RIGHT OF WAY PLAN OF THE
BENSON - MAMMOTH
STATE HIGHWAY
PROJECT NO. S-358-706
PIMA
COUNTY

BENSON-MAMMOTH HIGHWAY
REDINGTON BRIDGE-PINAL COUNTY LINE SEC.
PIMA COUNTY

PROJECT NO.	S-358-706
DRAWING NO.	D-10-T-321
SHEET NO.	2 of 17
DRAWN BY	J.G.
DATE COMP.	8-4-70
SCALE	
CONSULTANT	ENG. CORP OF AMERICA

PROJECT NO.	S-358-706
DRAWING NO.	D-10-T-321
SHEET NO.	3 of 17
DRAWN BY	Phil Hamel
DATE COMP.	8-4-70
SCALE	See Below
CONSULTANT	ENG. CORP OF AMERICA

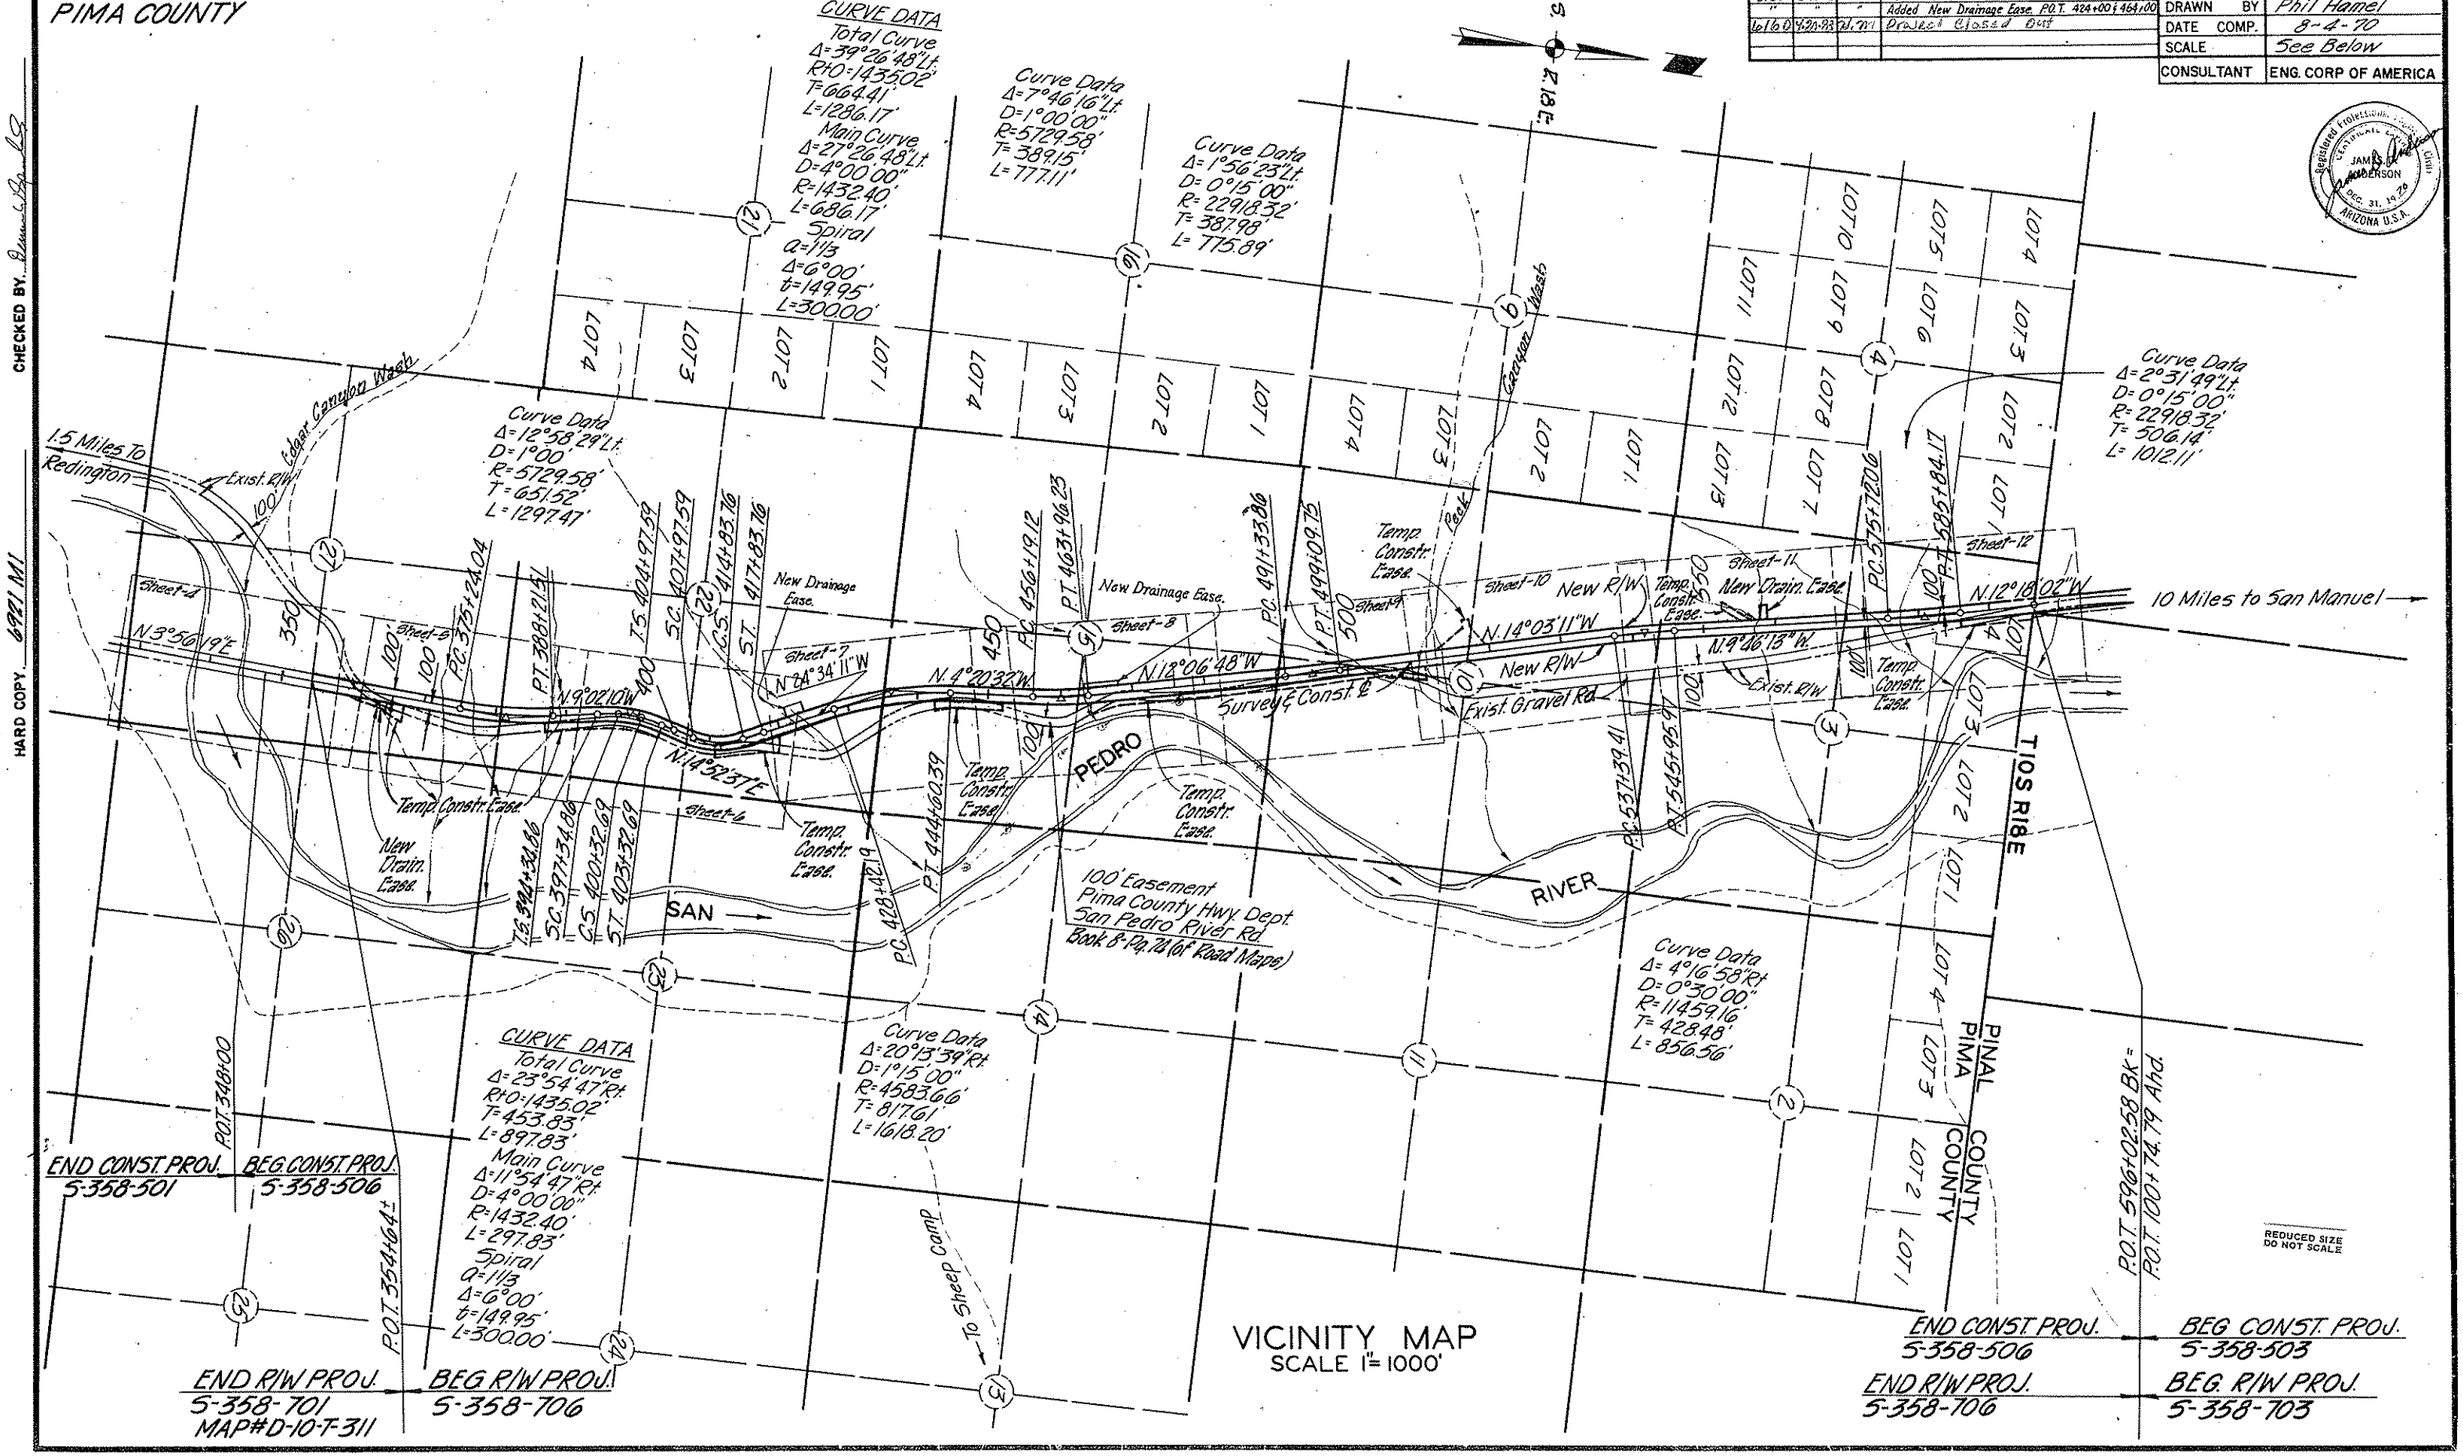
REVISIONS			
C.O. No.	DATE	BY	DESCRIPTION
3174	1-20-72	D.G.M.	Changed Drawing Number & Added Note.
3167	3-10-72	G.H.	Deleted T.C.E. P.O.T. 389+00, 515+00 & P.O.C. 582+
"	"	"	Added New Drainage Ease. P.O.T. 424+00 & 464+00
6160	4-20-73	J.M.	Project Closed Out

PROJECT NO.	5-358-706
DRAWING NO.	D-10-T-321
SHEET NO.	5 of 17
DRAWN BY	R.J.H.
DATE COMP.	8-4-70
SCALE	1"=100'
CONSULTANT	ENG. CORP. OF AMERICA

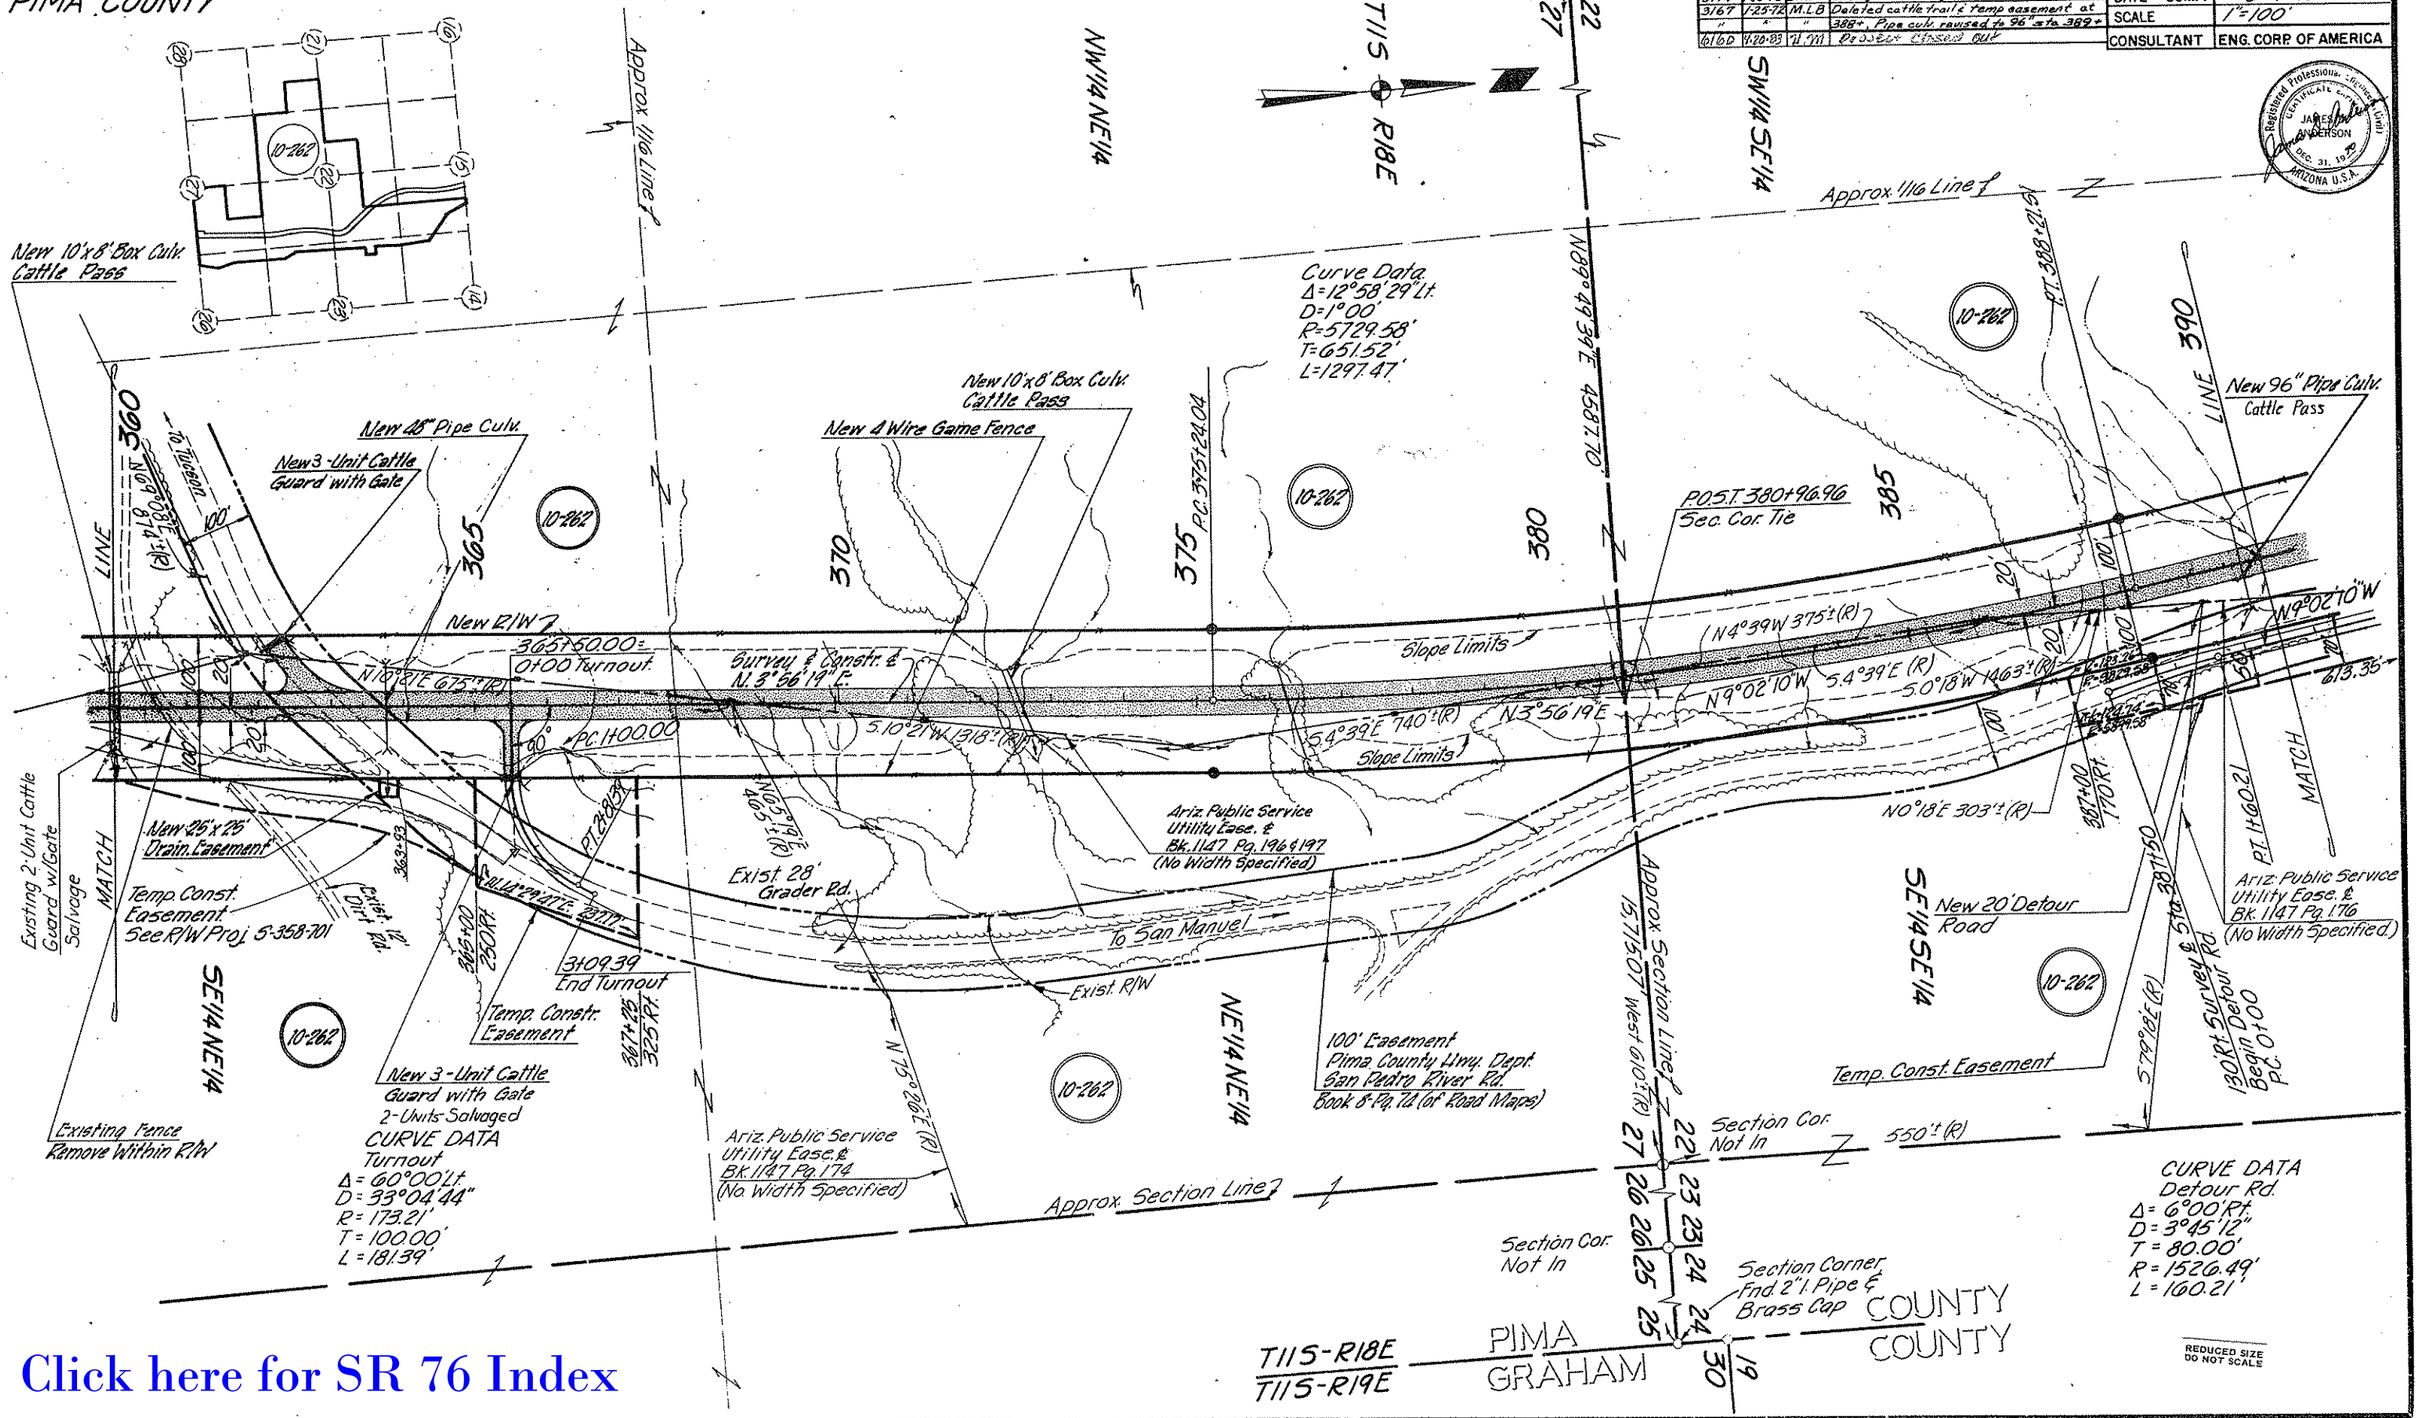
REVISIONS			
C.O. No.	DATE	BY	DESCRIPTION
2747	10-26-70	D.J.M.	CHANGED CALLOUT OF CATTLE GUARDS AT L.T. STA. 362+50 & RT. STA. 365+00 TO 3-UNIT. ADDED CALLOUT EXISTING 2-UNIT C.G. STA. 360+00
3174	1-20-72	D.G.M.	Changed Drawing Number & Added Note.
3167	1-25-72	M.L.B.	Deleted cattle trail & temp easement at 388+. Pipe culv. raised to 96" at 389+
"	"	"	
6160	4-20-83	[illegible]	Pc 3+00 closed out

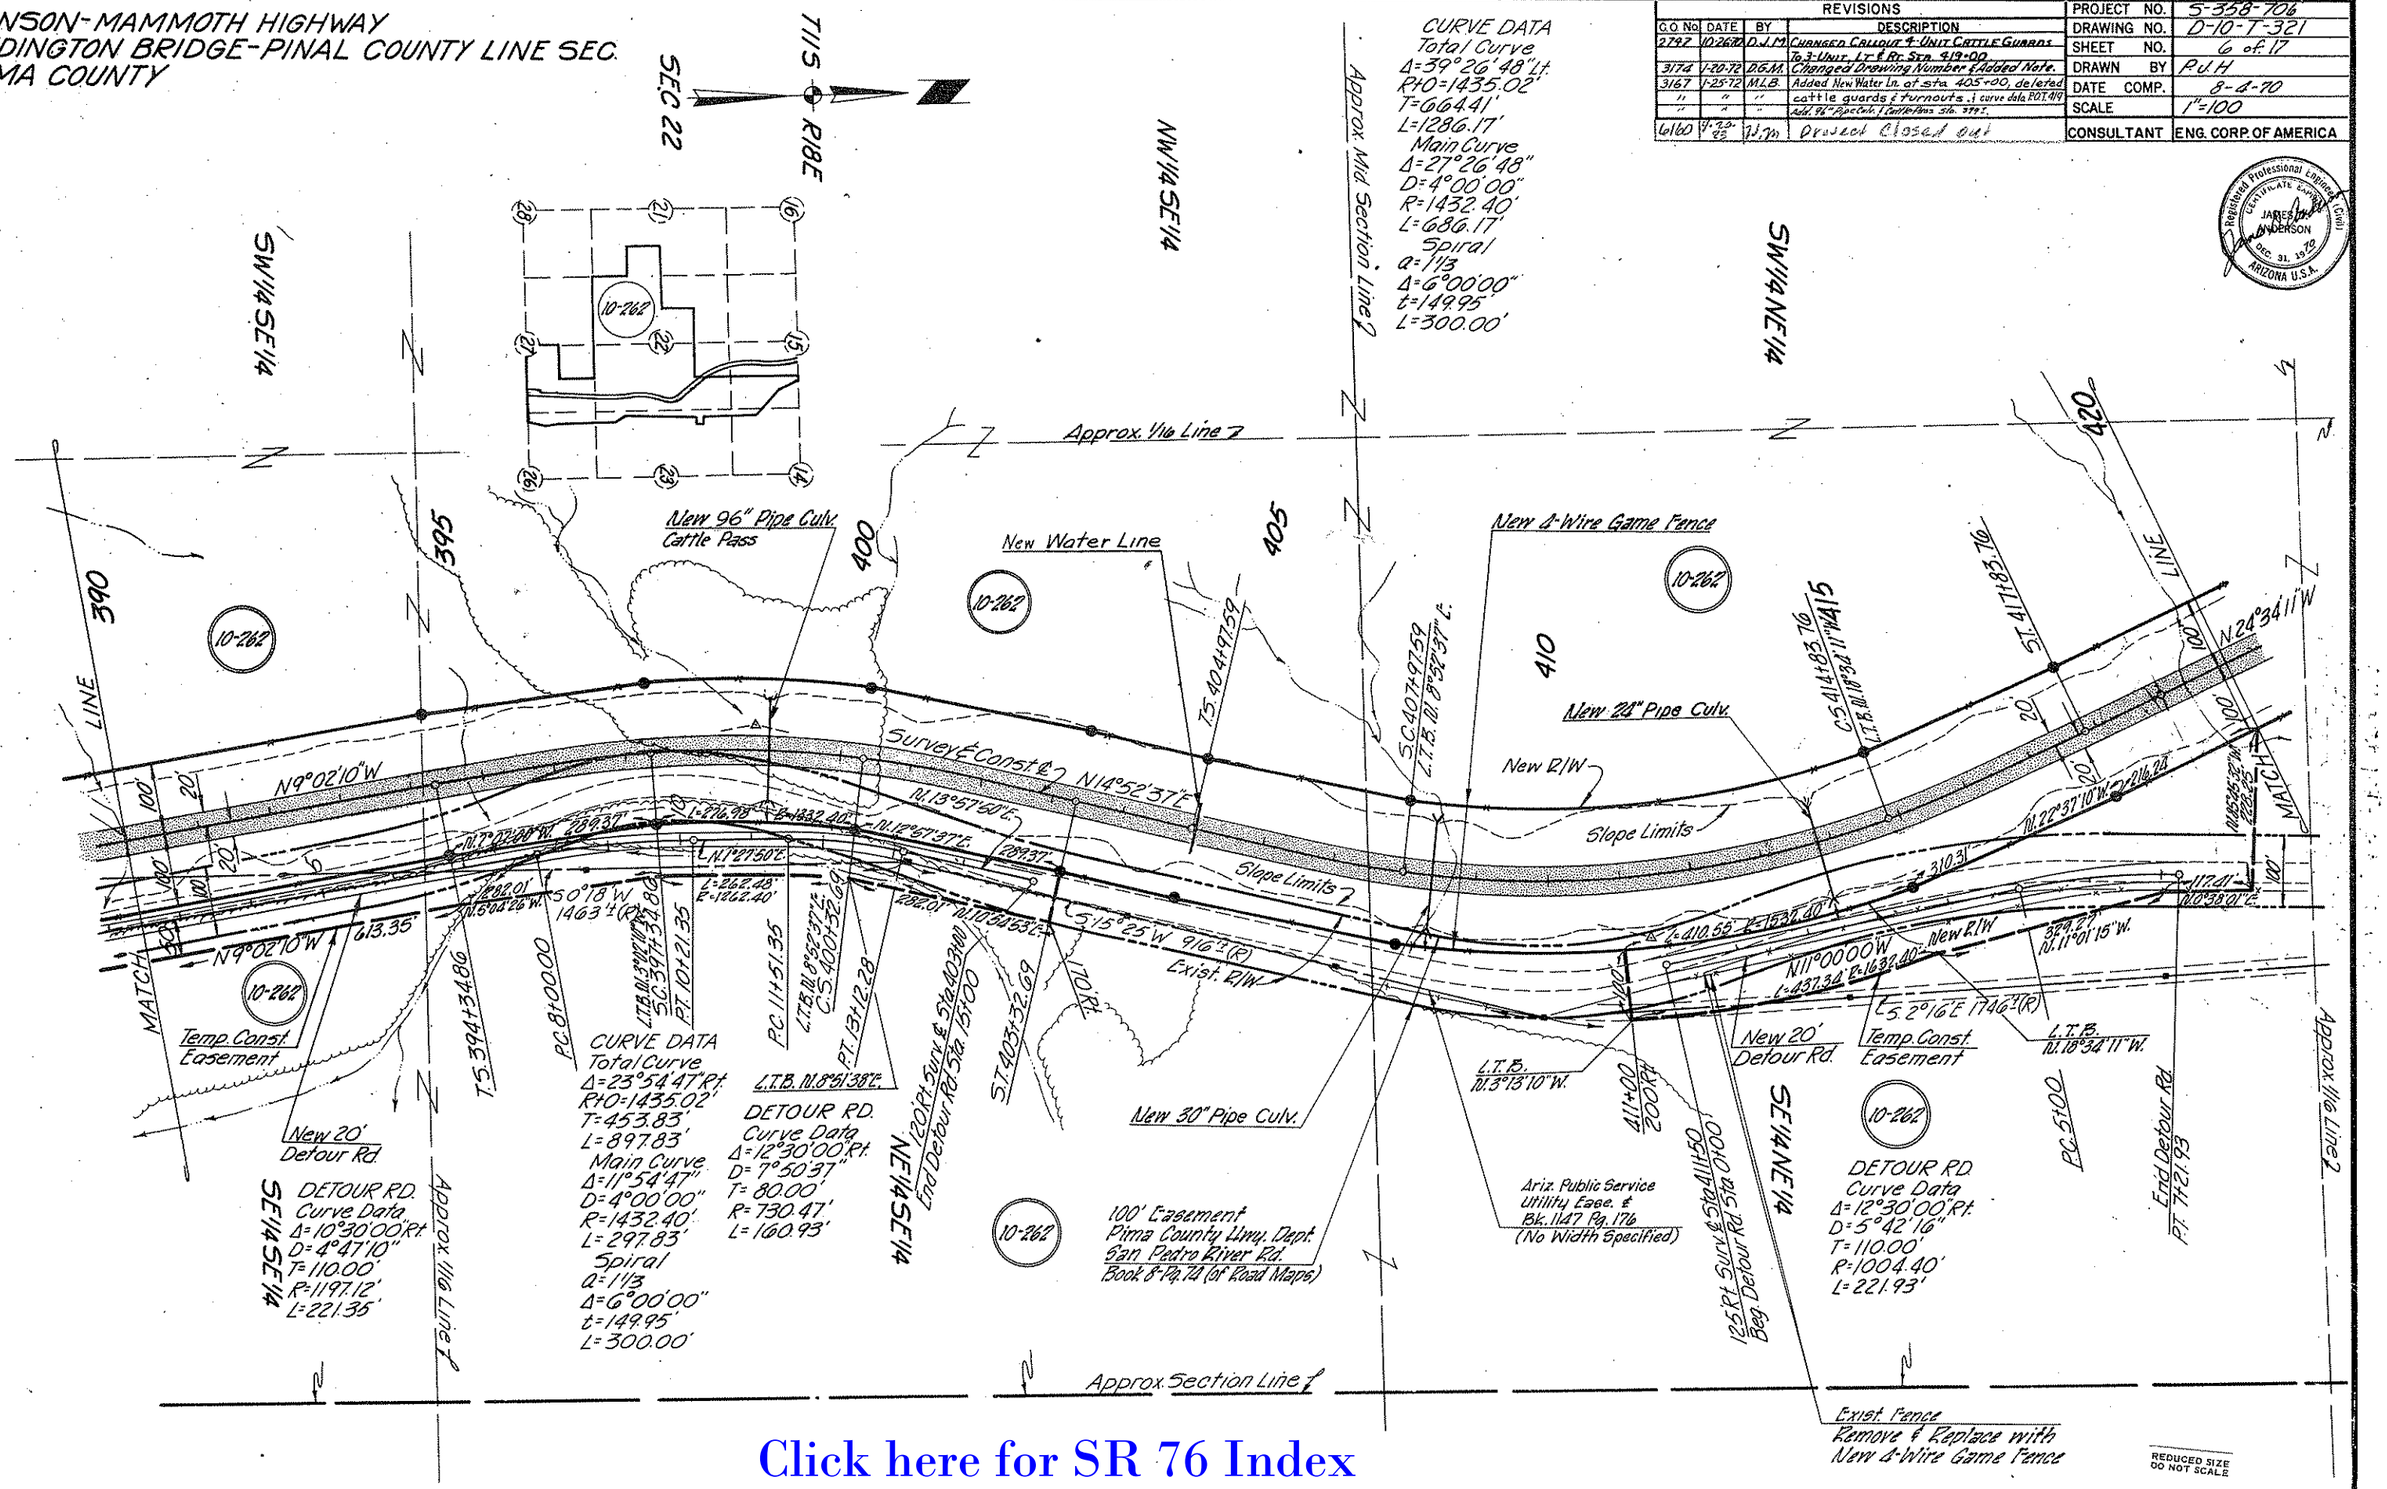
REVISIONS					
G.O. No.	DATE	BY	DESCRIPTION	PROJECT NO.	S-358-706
2792	10-26-70	D.J.M.	Changed Callout 4-Unit Cattle Guards To 3-Unit, 1-8 Rc. Sta. 419+00	DRAWING NO.	D-10-T-321
3174	1-20-72	D.G.M.	Changed Drawing Number & Added Note.	SHEET NO.	6 of 17
3167	1-25-72	M.L.B.	Added New Water Ln. at sta. 405+00, deleted	DRAWN BY	P.U.H.
"	"	"	cattle guards & Turnouts, curve data, ROT. 419	DATE COMP.	8-4-70
"	"	"	add. 96" Pipe Culv. & Turnouts sta. 399+.	SCALE	1"=100
6160	4-20-73	J.J.M.	Drawing Closed Out	CONSULTANT	ENG. CORP. OF AMERICA
